# Technical Memorandum

**Re:** Spring Creek Hydrology Review

## Technical Memorandum

**To:** Della Schall Young, Young Environmental Consulting Group  
**From:** Jeff Weiss and Kallie Doeden, Barr Engineering  
**Subject:** Spring Creek Assessment Summary  
**Date:** September 6, 2019  
**Project:** 23101028.05

Figure 20. Carver SWCD 2019 proposed design for Site 1 (112 5th Street West)

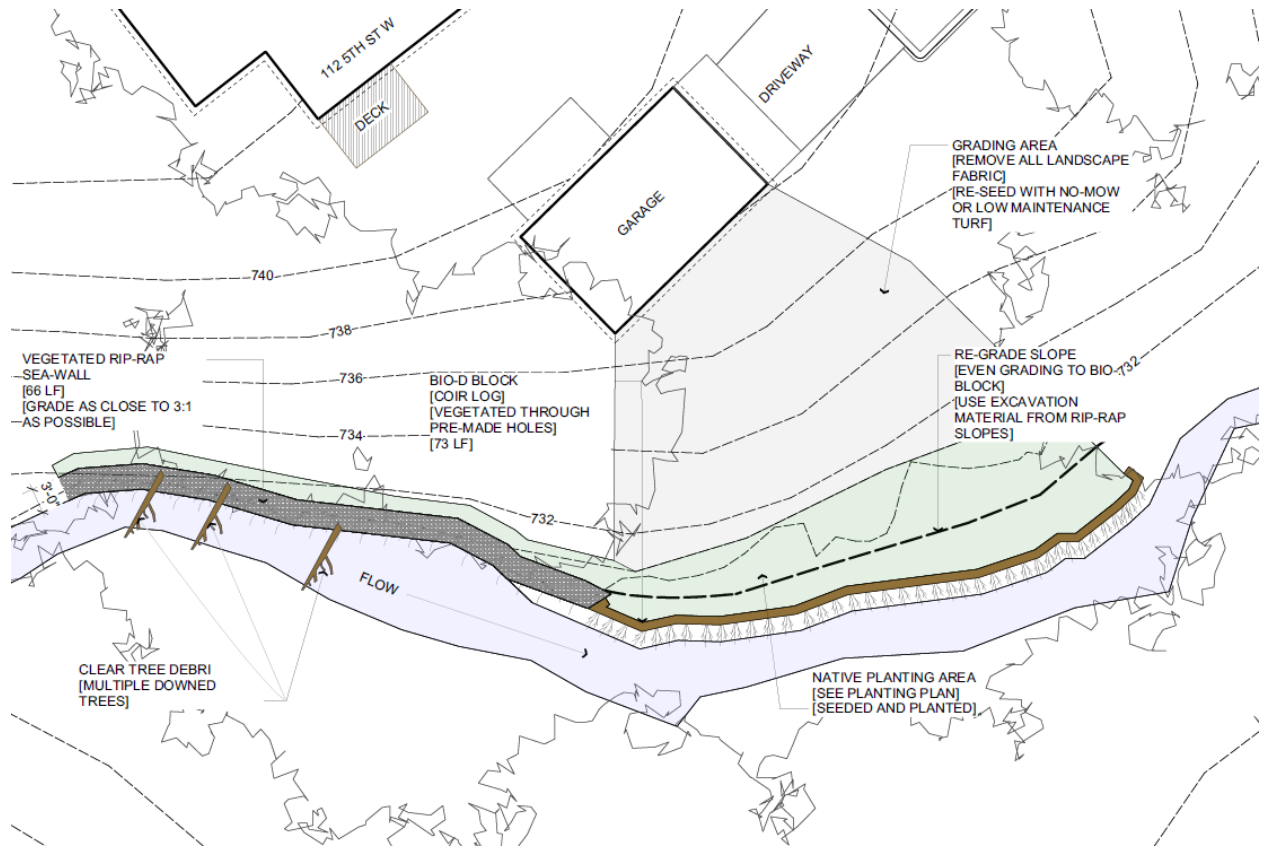
The SWCD has proposed vegetated riprap and Bio-D block walls with native plantings along the left bank at Site 1 to prevent Spring Creek from further eastward migration (Figure 20), at a cost of approximately \$75,000. For Site 2, the SWCD recommended a more robust combination of riprap, Bio-D block, native plantings, and removal of the failing concrete walls (Figure 21), at a cost of approximately \$88,000.

Still assuming the same underlying sandy loam soils comprise the creek banks but are vegetated with short native and bunch grasses as was observed in the field, Site 2 is stable, however Site 1 would be expected to show signs of erosion (as it does currently). The proposed SWCD designs of Bio-D block walls and riprap should be sufficient to withstand the expected velocities and stresses under the current conditions. We recommend evaluating the size of the riprap to ensure it can withstand the expected velocities at Site 1.

- While the Carver SWCD designs appear to be appropriate with slight modifications to the riprap sizes, rather than embark upon single restorations for these individual landowners, we recommend that the District reach out to all Spring Creek landowners in this reach to determine if there is interest for a larger project and how long and where this erosion has been occurring.

- The structures at Site 1 do not appear to be under immediate threat from Spring Creek. We recommend reevaluating the need for stabilization pending the results of the monitoring and vegetation management study.

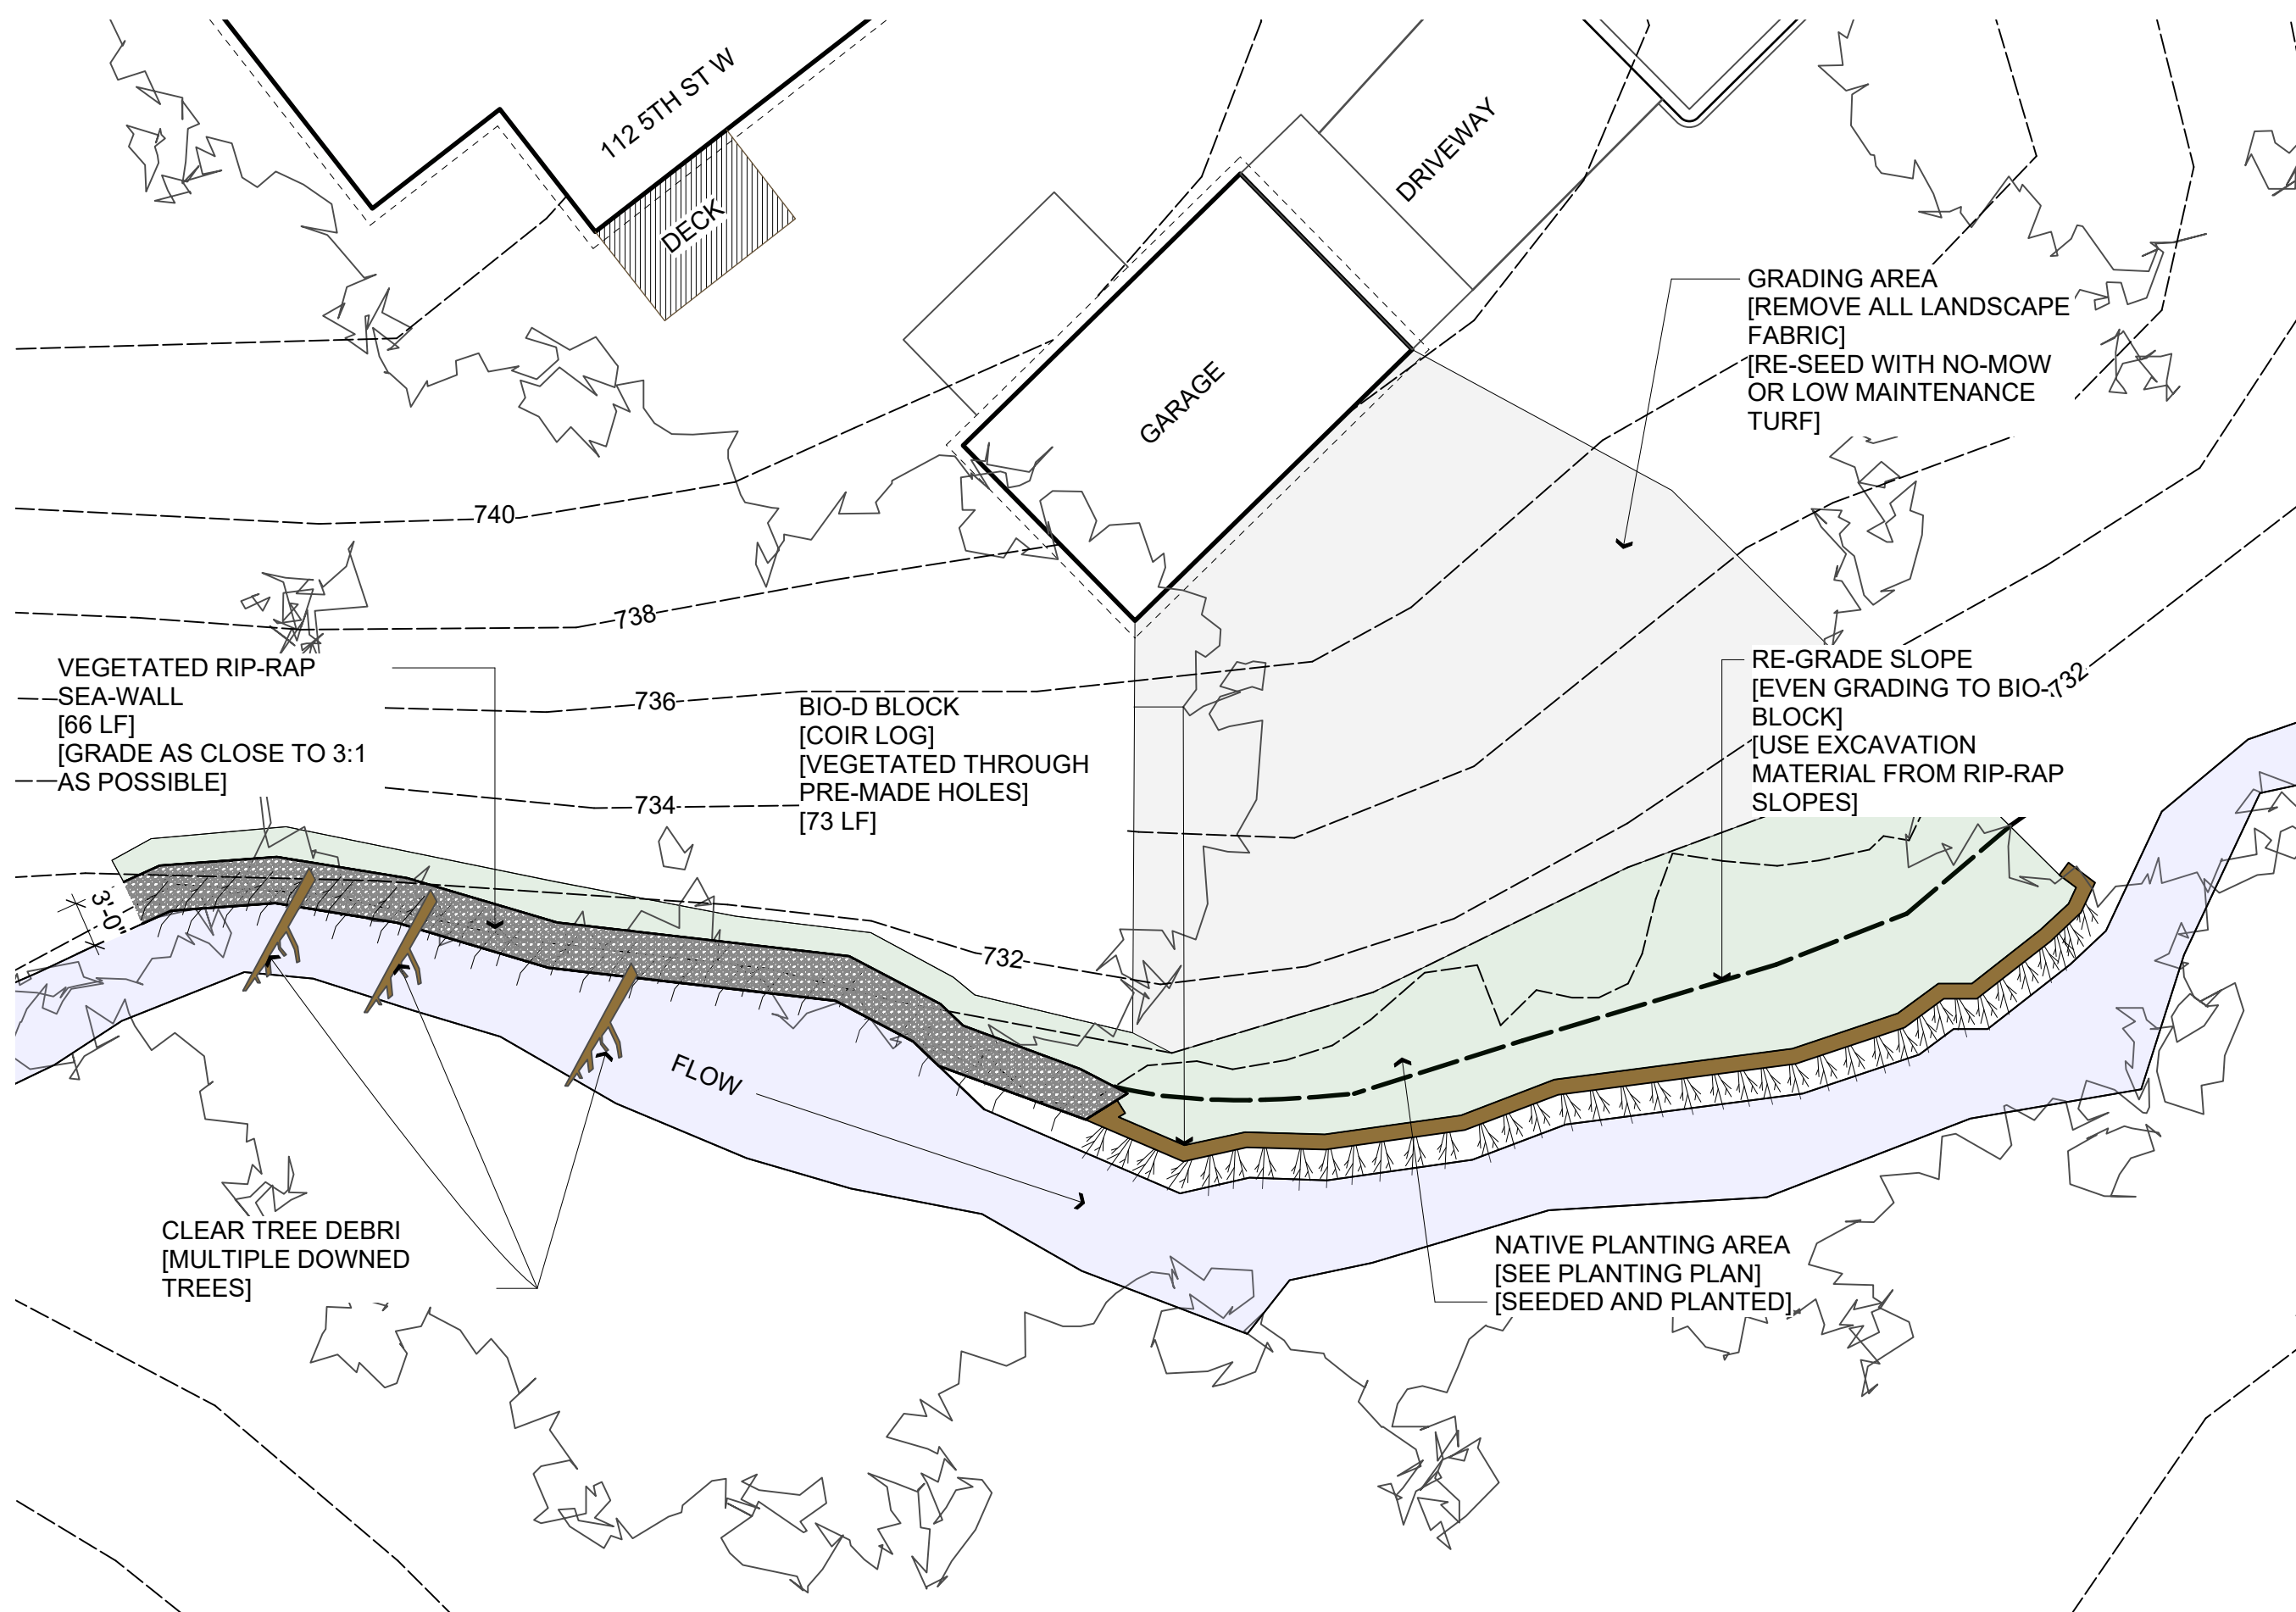
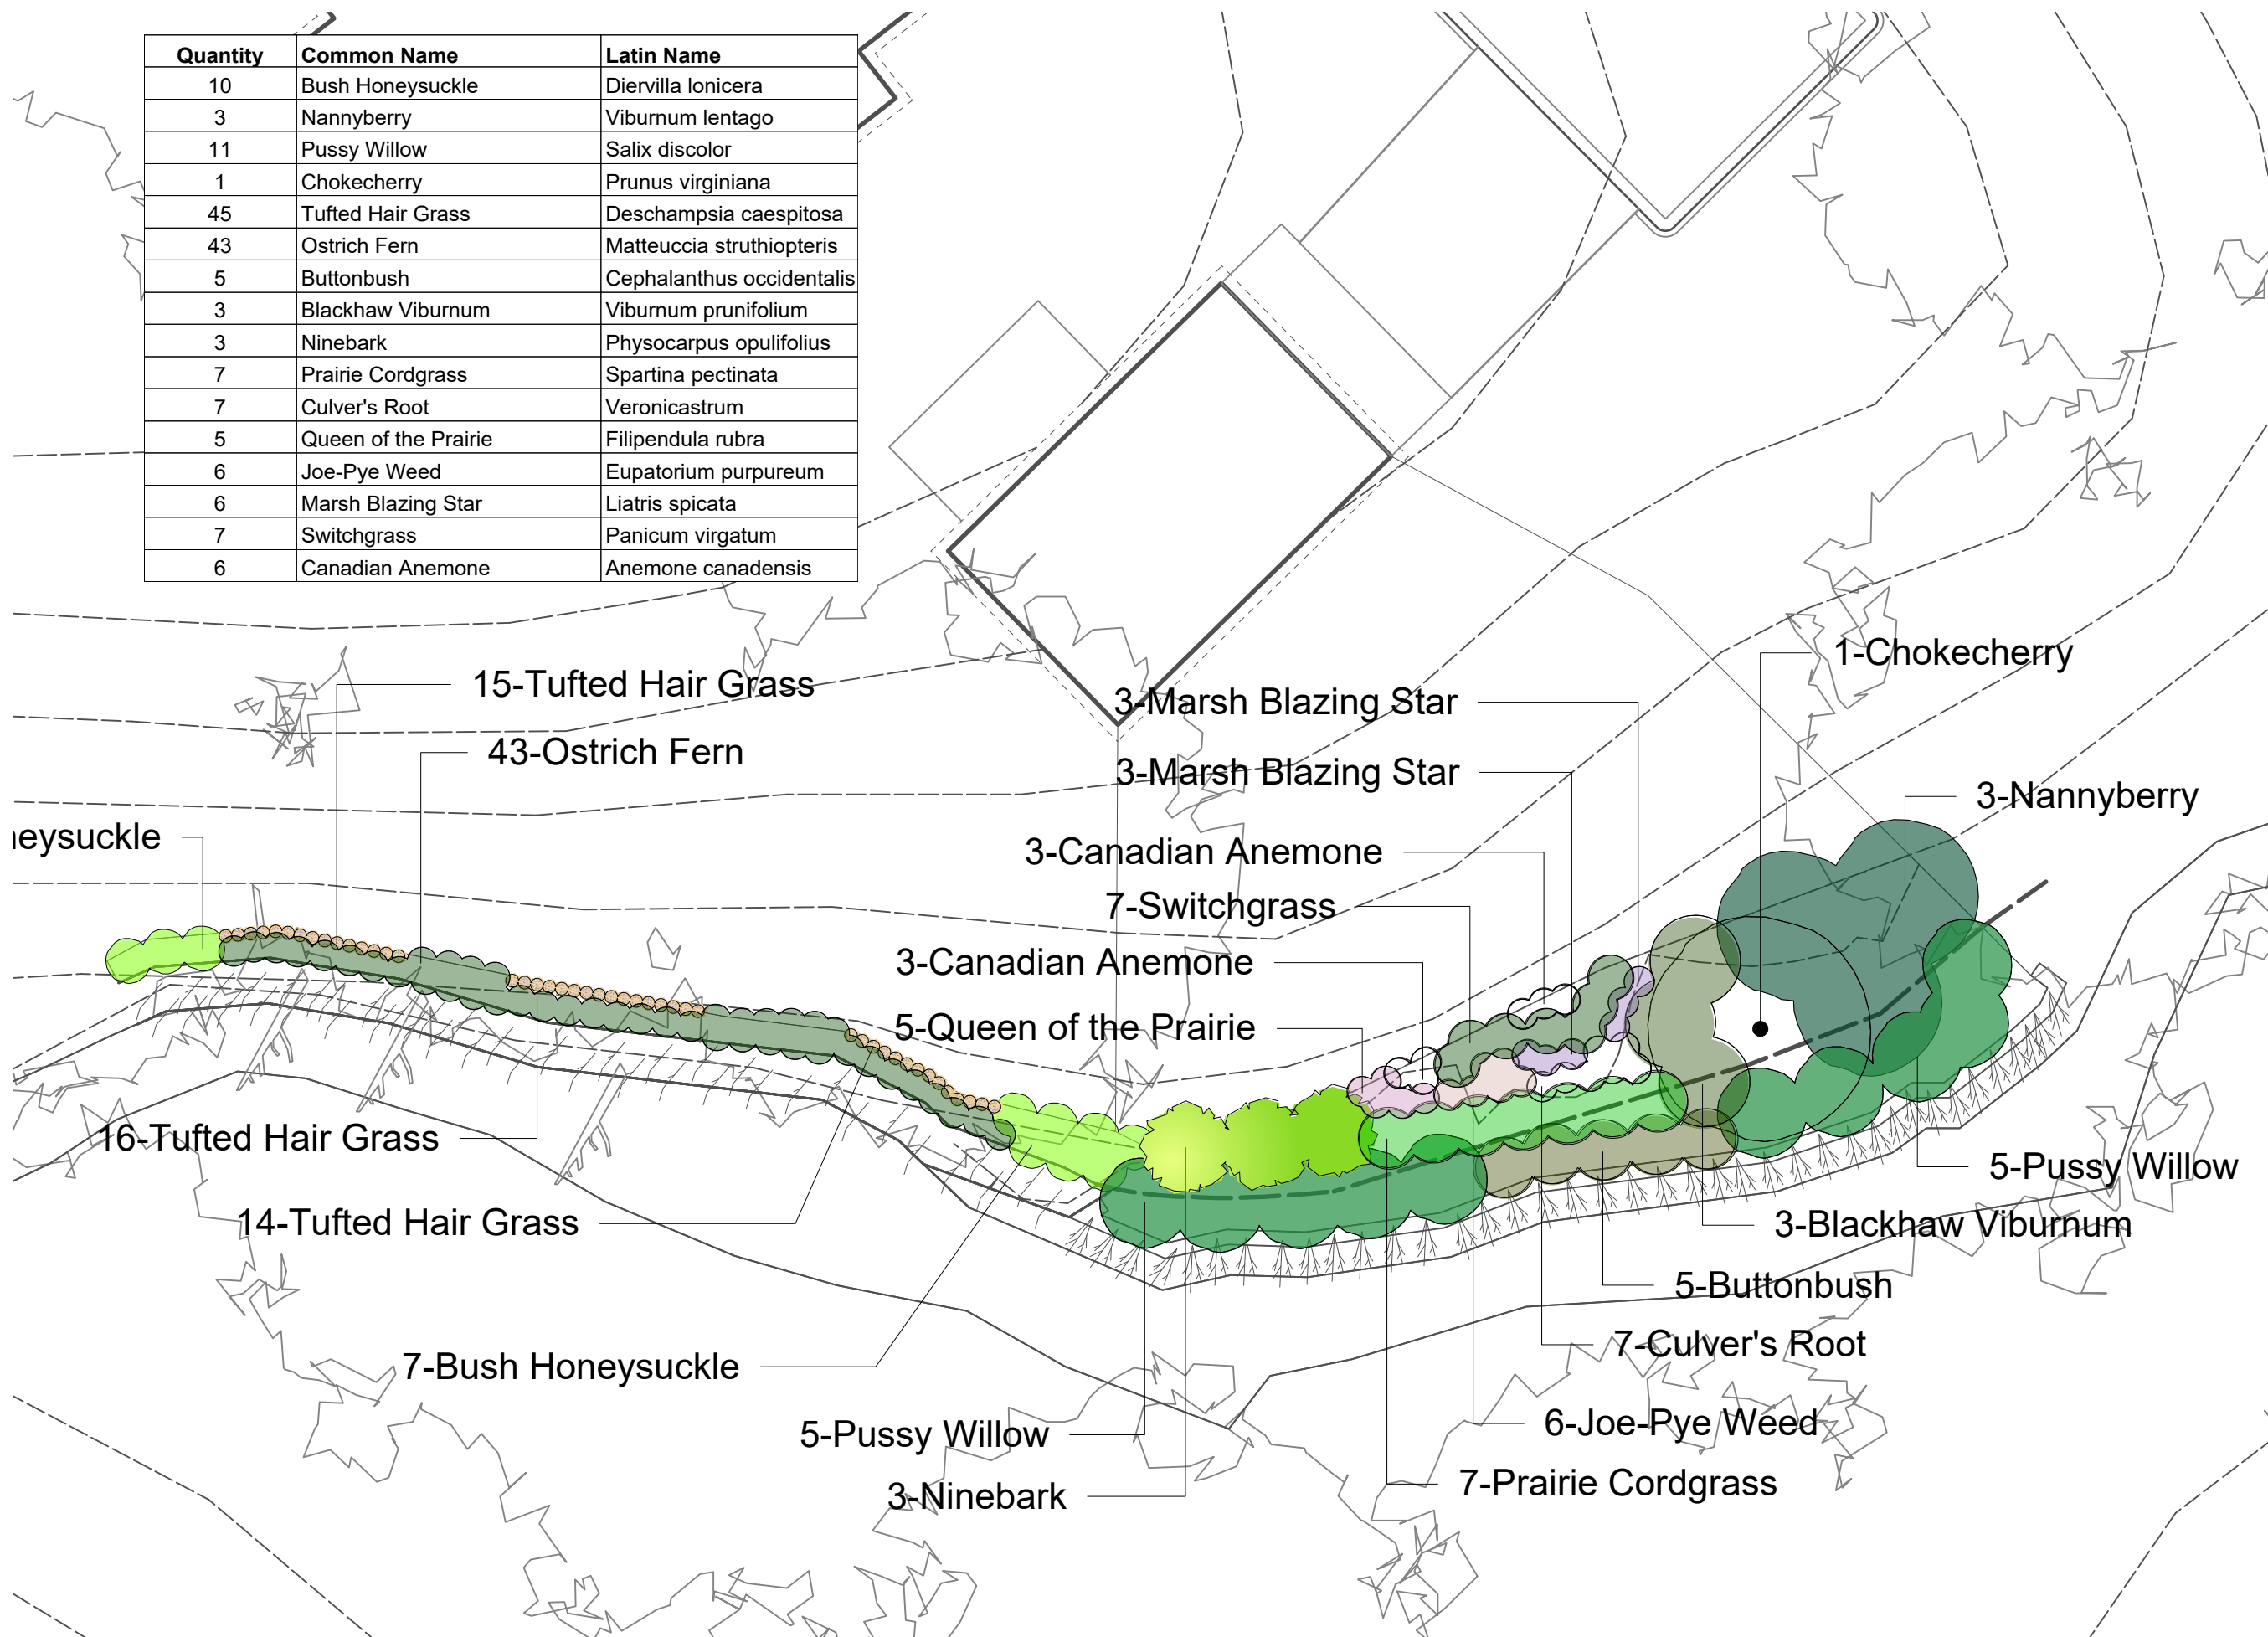
The Carver SWCD concept plan includes removing fallen trees, using riprap to armor the channel where banks are eroding, and revegetating with deep rooted species. Barr concurs with the general concept with the following considerations:

- 1) Additional assessment of the hydrology should be completed to better understand potential changes that have already occurred and may occur into the future, and to help design stabilization measures.
- 2) Cross vanes should also be installed to provide additional grade control. They may also be used to elevate the stream bed to reconnect the stream to the former floodplain.
- 3) If the cross vanes cannot completely restore a floodplain connection, then additional grading should be considered to create a floodplain.

- At 404 Broadway, restore the channel to the previous alignment, which will provide additional space between the garage and the creek.
- Restore the previous channel alignment at 112 5<sup>th</sup> Street, with consideration of the modified hydrology draining to this location.
